Technical Service Bulletin: tsb100081

Oil Volumes for Isolated Oil Gasket

Isolation Gasket

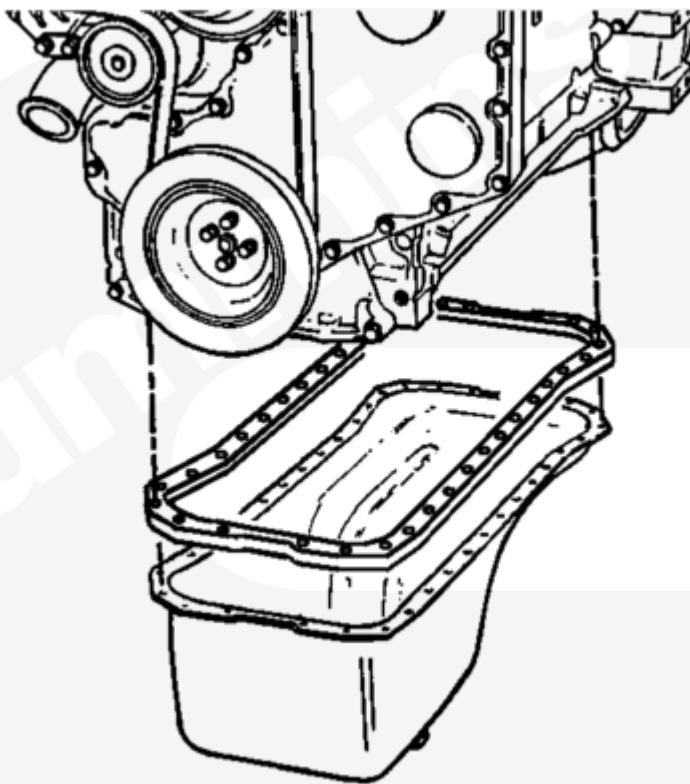
Certain options and kits require the addition of extra oil when performing an oil change. Both the isolation oil pan gasket option and the bedplate (block stiffener) option each require additional oil to be added during the oil change. The dipstick tube does **not** need to be changed.

Engines with the following part numbers for the isolation gasket or the bedplate **must** add extra oil.
